## Burlington Development Review Board

### **BURLINGTON DEVELOPMENT REVIEW BOARD Wednesday March 8, 2017, 5:00 PM PUBLIC HEARING NOTICE**

## Department of Planning and Zoning

From: Mary O'Neil, AICP, Principal Planner

## C1.1

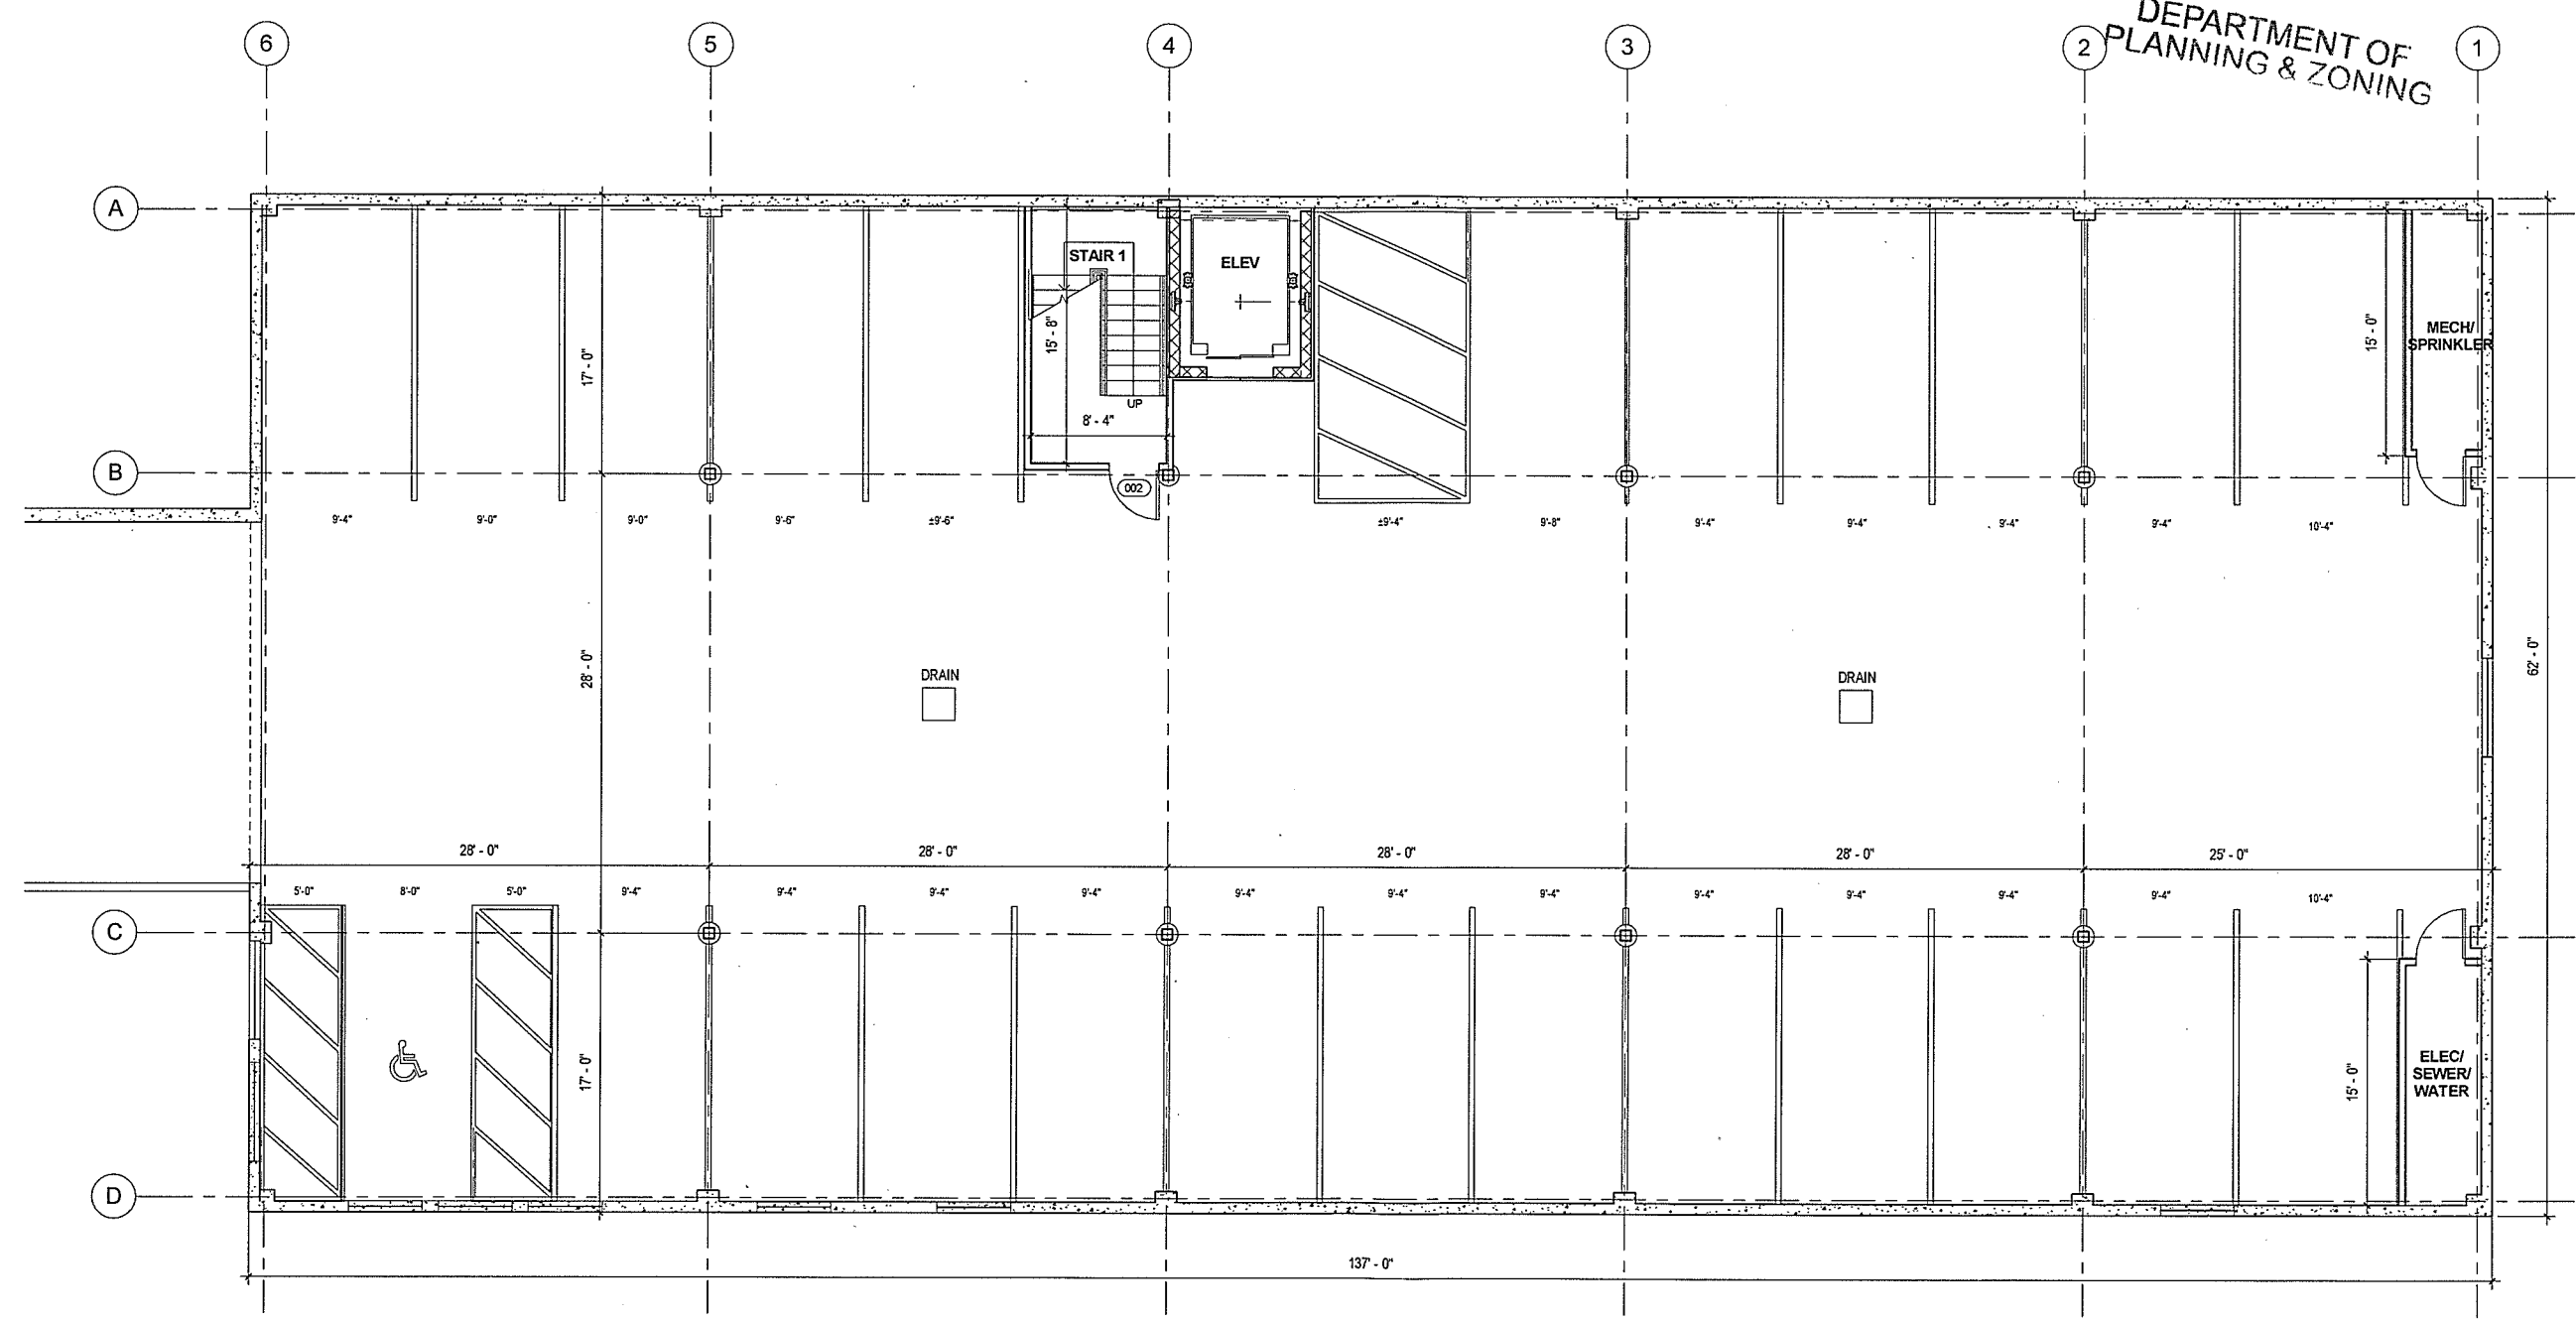
A plan for snow removal and/or storage is included on revised drawings (C1.1.)

Trash and recycling for all uses will be provided in the westerly building, see Plan C1.1. There shall be no exterior totes for the residential use.

DRAWING:  
GARAGE  
PLAN

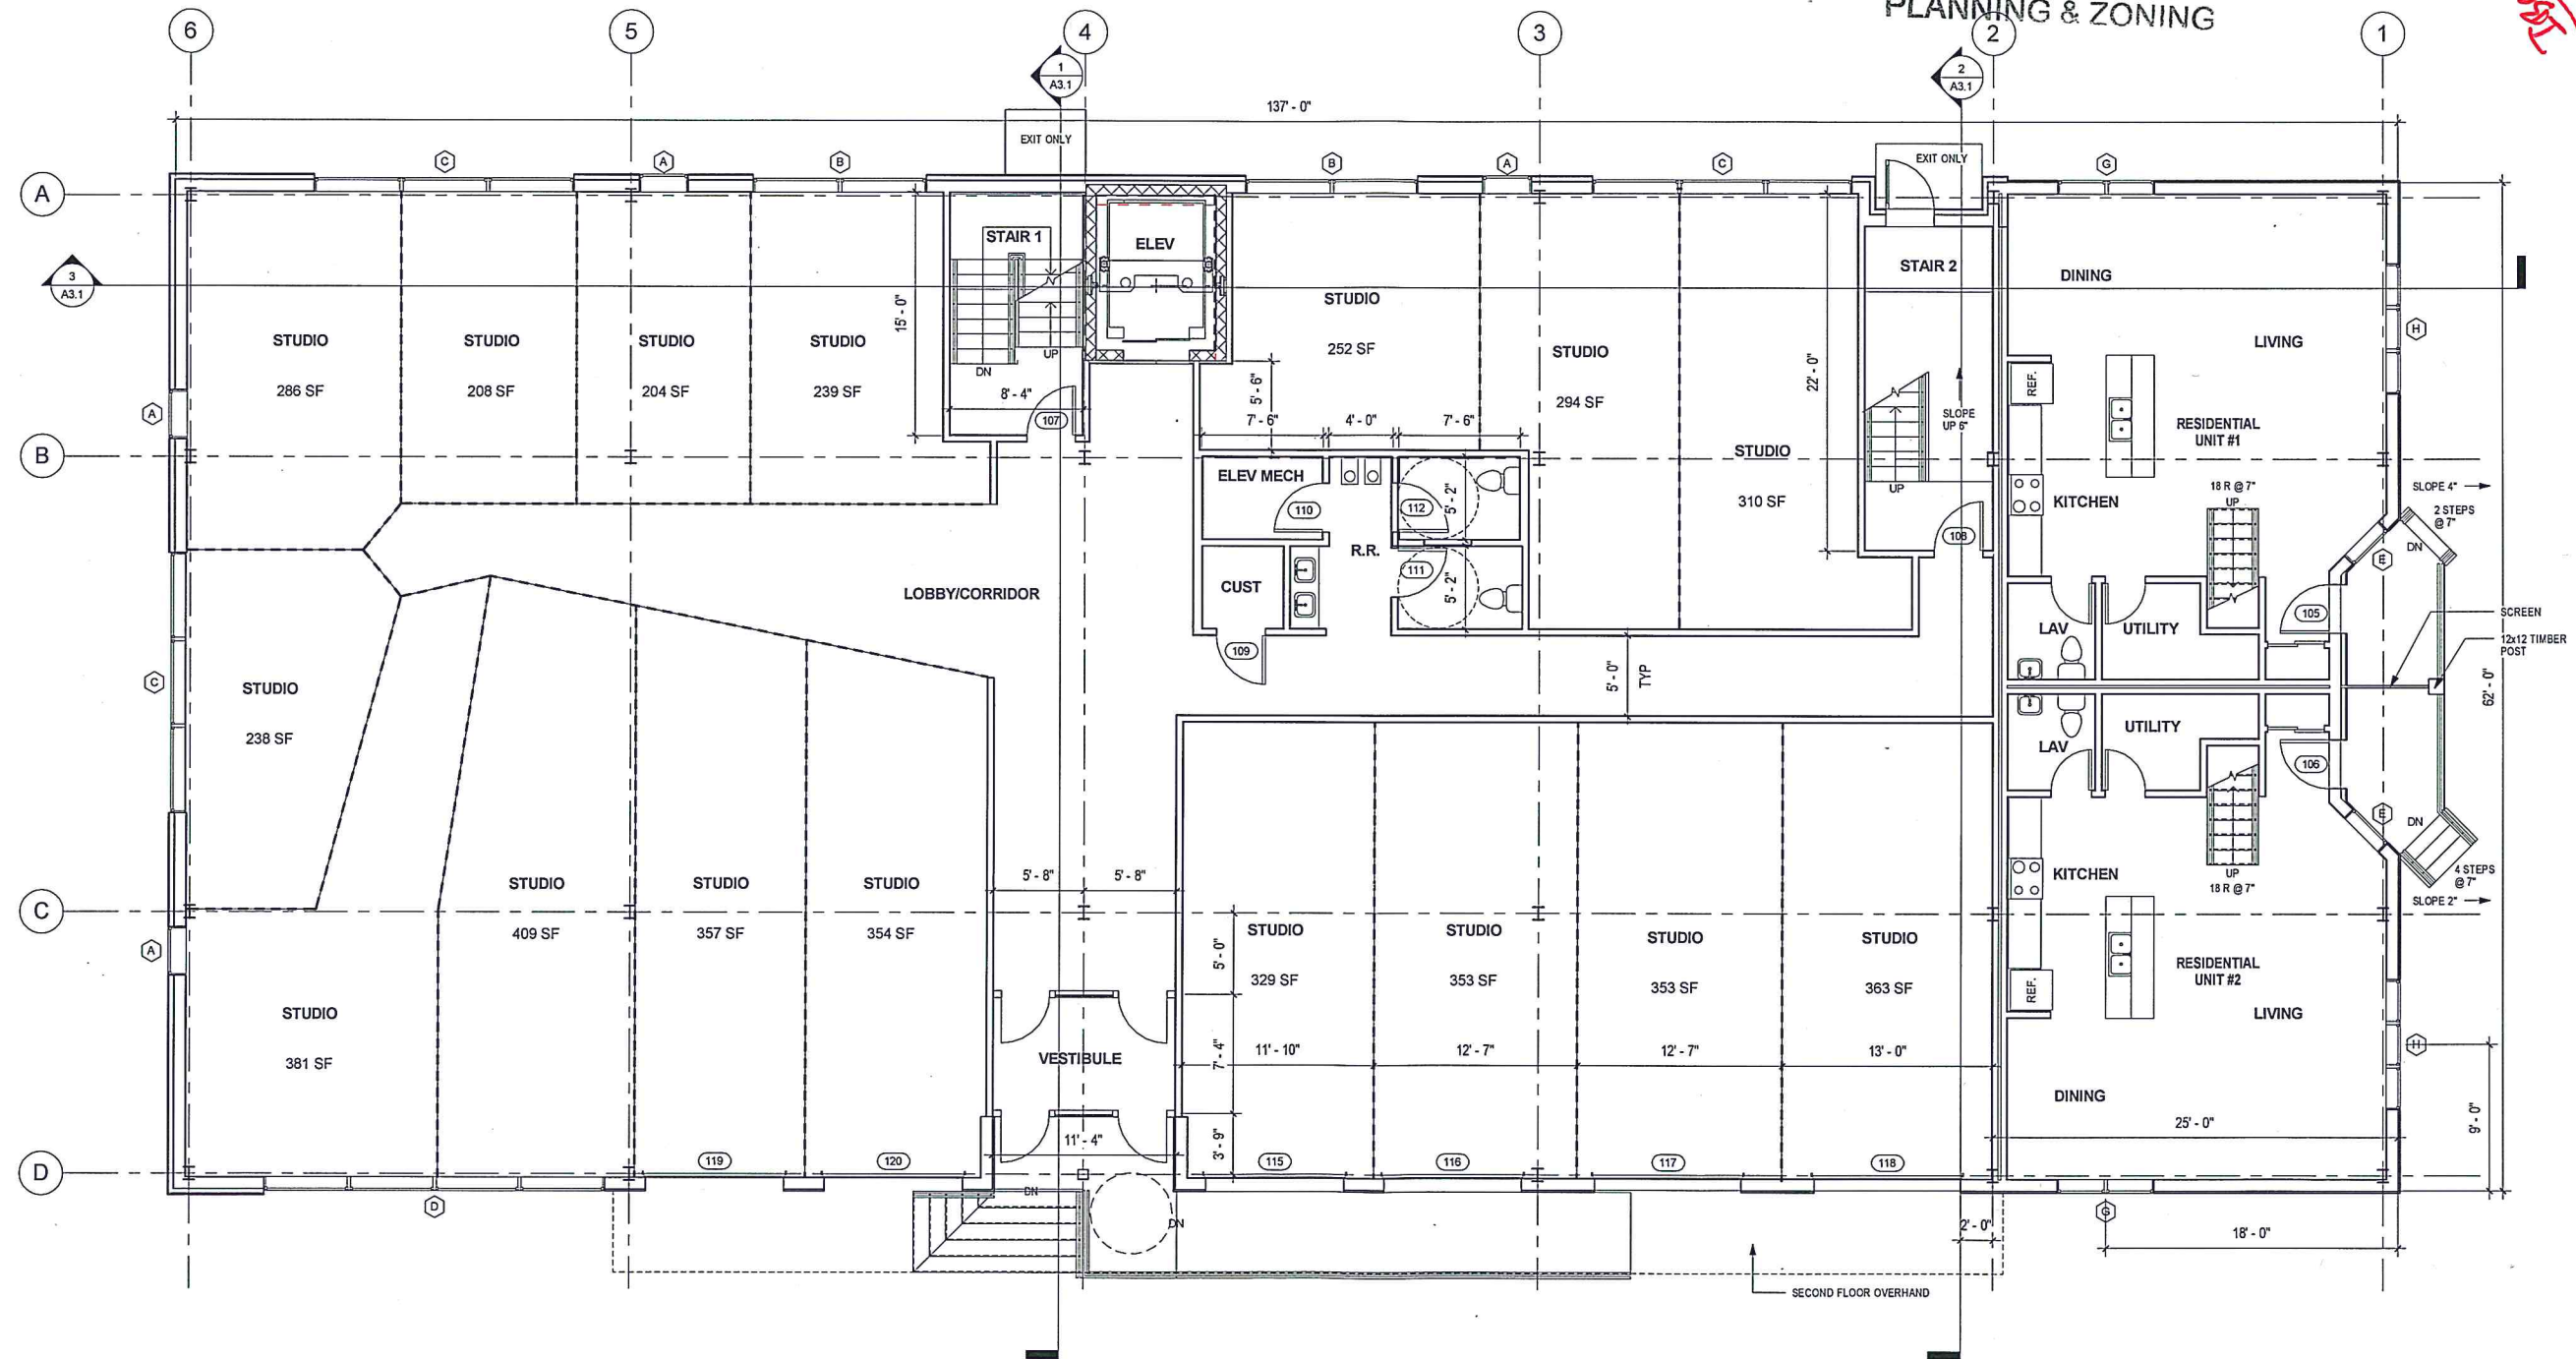
Revised Plan LS1 shows 25 parking spaces within the parking deck; plan A1.1 has 24. The handicap parking space is located in different locations in each plan. The attached narrative defines 20 spaces within the parking deck (See Exhibit B, page 2.) Plans must be consistent and accurate for development proposed.
